# CITY PLANNING COMMISSION

**APPLICATION:** Planning Commission review of two office/warehouse buildings on 3.85+ vacant acres in the Heavy Commercial-Review (C-4-R) and General Commercial (C-2) Zones

**LOCATION:** NE corner Northgate Boulevard and Patio Drive

**PROPOSAL:** The applicant is requesting the necessary entitlement to construct two office buildings on part of Sutter Business Park.

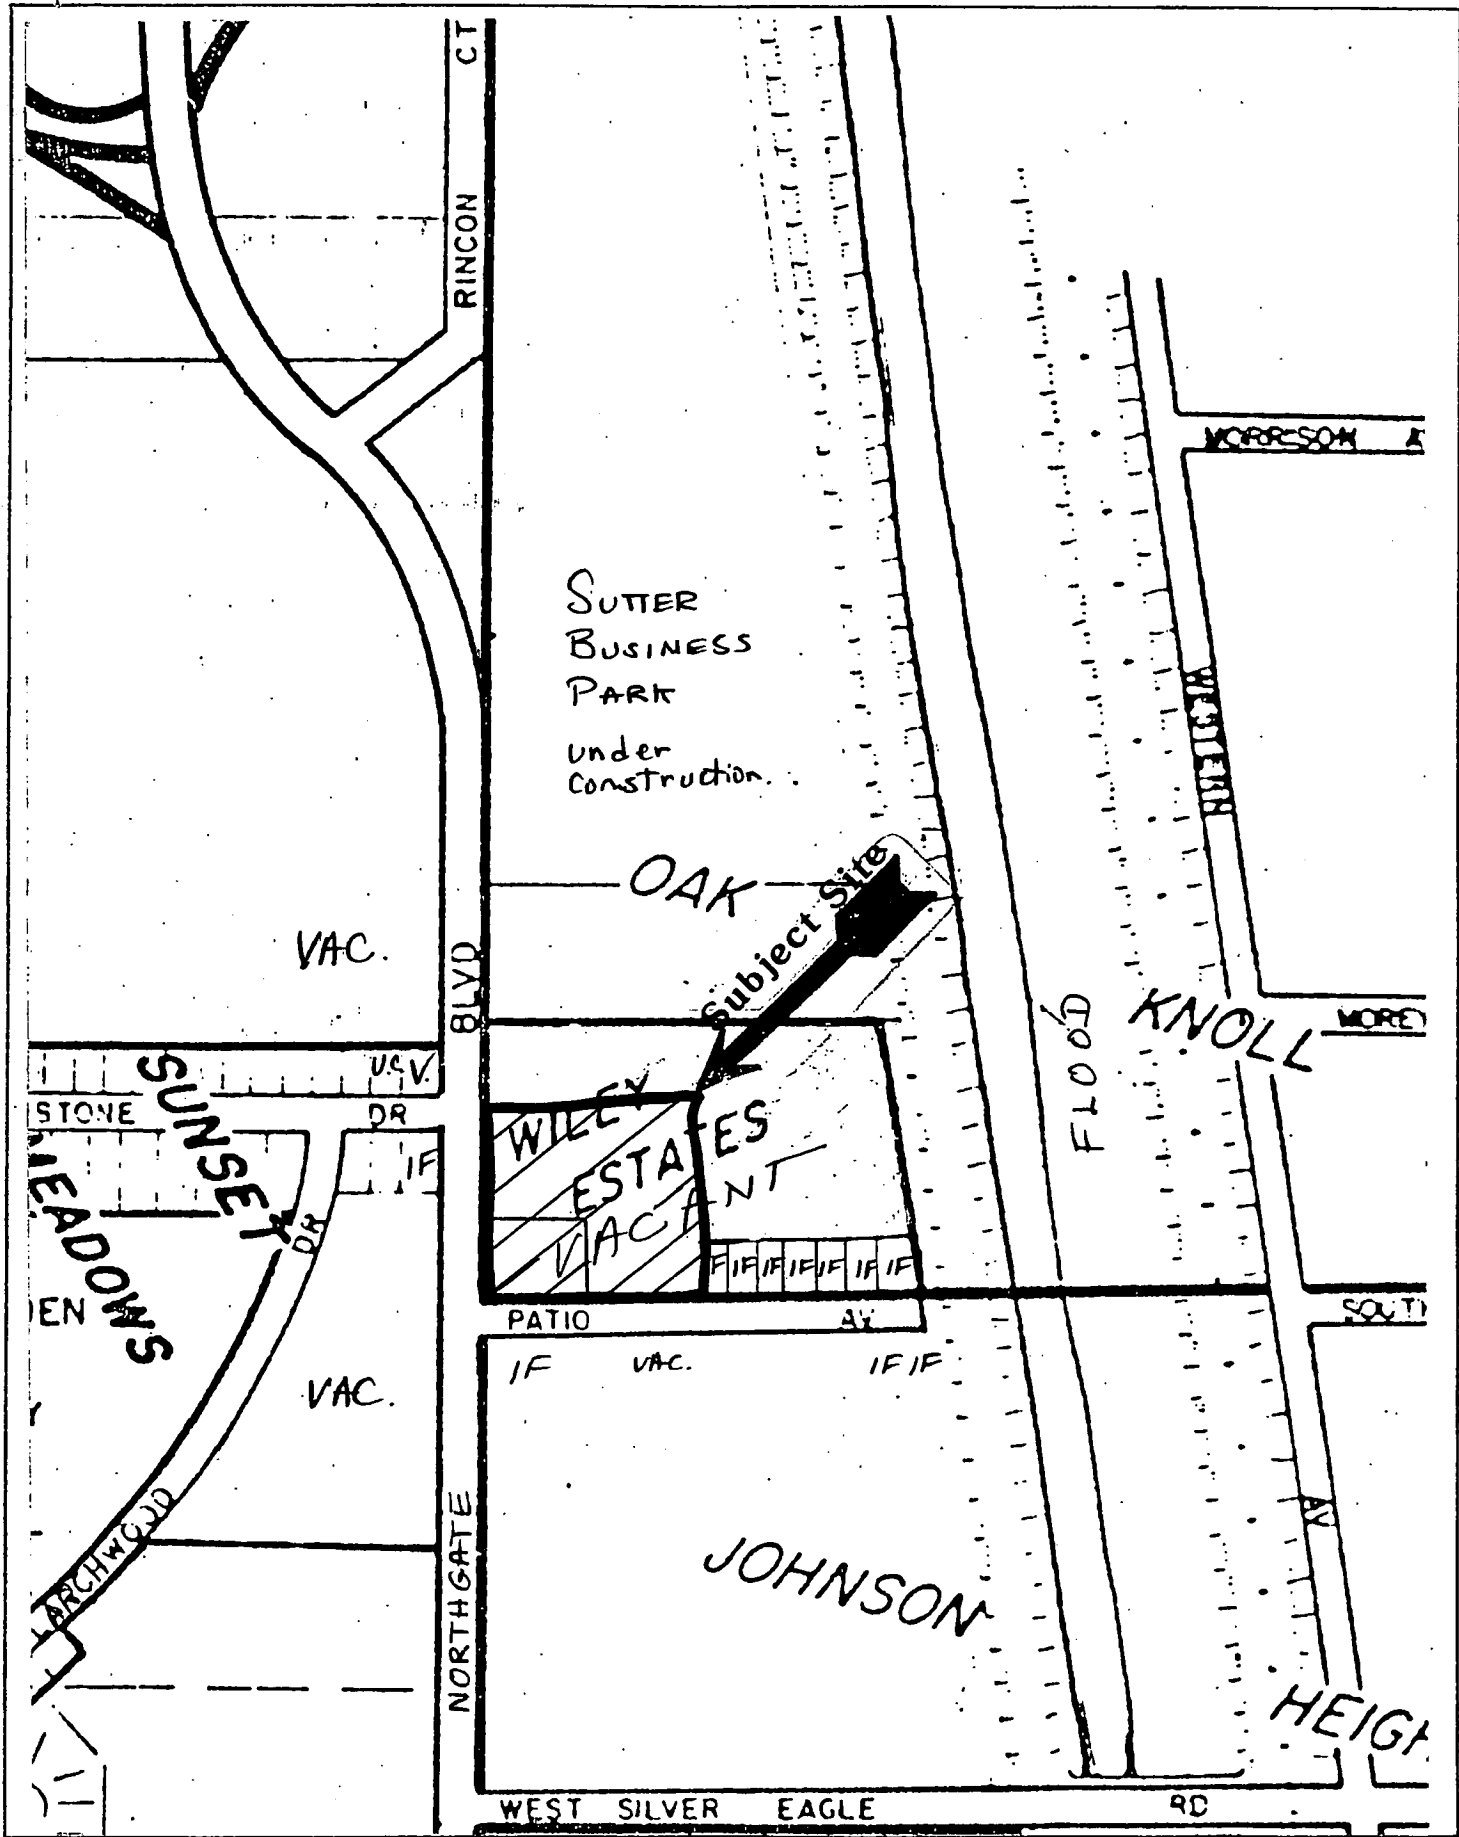
- a. No permits will be issued for driveways if property lines bisect driveways;
  - b. A minor circulation problem at the east end should be corrected. See staff recommendation-Exhibit A. (This will reduce the number of spaces by two.)
4. The trash enclosures should be enclosed with a minimum six-foot masonry wall, matching the main building material, with heavy gauge metal gates. It should be designed to allow walk-in access without having to open the gates.

6. Six parking stalls facing the west wing of Building H scale out to the 16 foot compact size. If they are to be standard 18 foot stalls, the applicant should be aware that the allowed two-foot overhand can only be over a landscaped area.

7. It should be noted that a portion of Building H is located in the General Commercial (C-2) zone which does not allow warehouse uses. The applicant/developer should rezone this C-2 portion to bring it into conformance with the rest of the parcel and its proposed use.

3. The project shall be redesigned so that property lines do not bisect driveways;
  4. Parking lot circulation shall be redesigned as in Exhibit A;
  5. The trash enclosure shall be enclosed with a minimum six-foot masonry wall matching the main building material, with heavy gauge metal gates. It should be designed to allow walk-in access without having to open the gates;

7. Six parking stalls facing the west wing of Building H shall be labeled "compact", or the area redesigned for vehicles overhanging a landscaped area;

8. The General Commercial (C-2) portion of this site shall be rezoned to bring it into conformance with the rest of this project and its proposed uses. This must be approved by the City Council prior to any occupancy of Building H.

EXHIBIT B

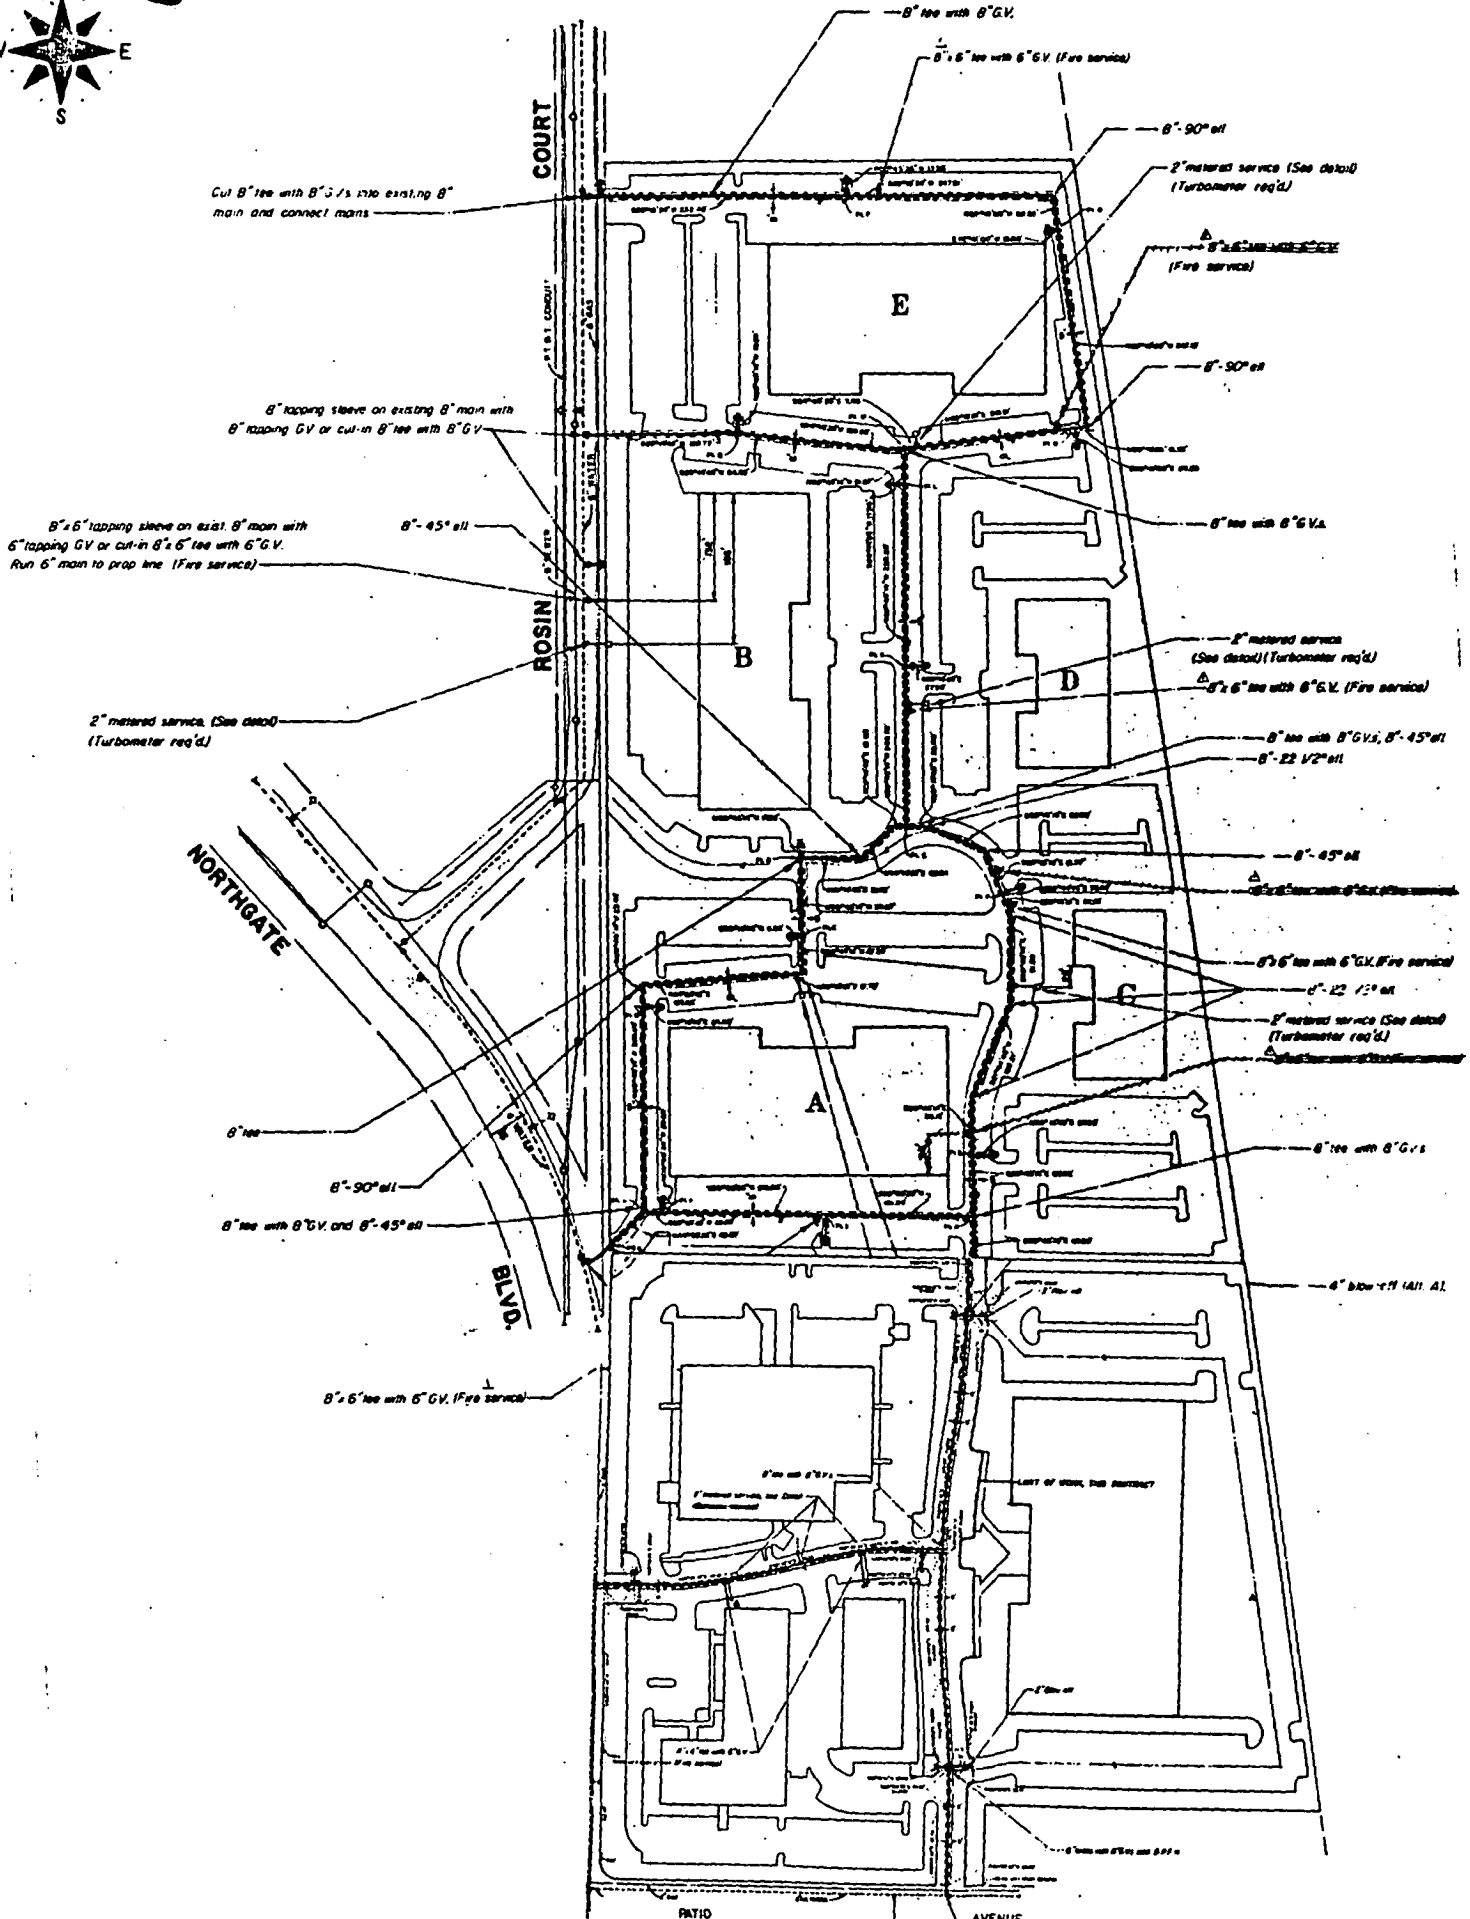
8. Earlier approvals for Sutter Business Park required a full schematic plan be provided. A rough schematic plan is attached as Exhibit B for the Commission's information.
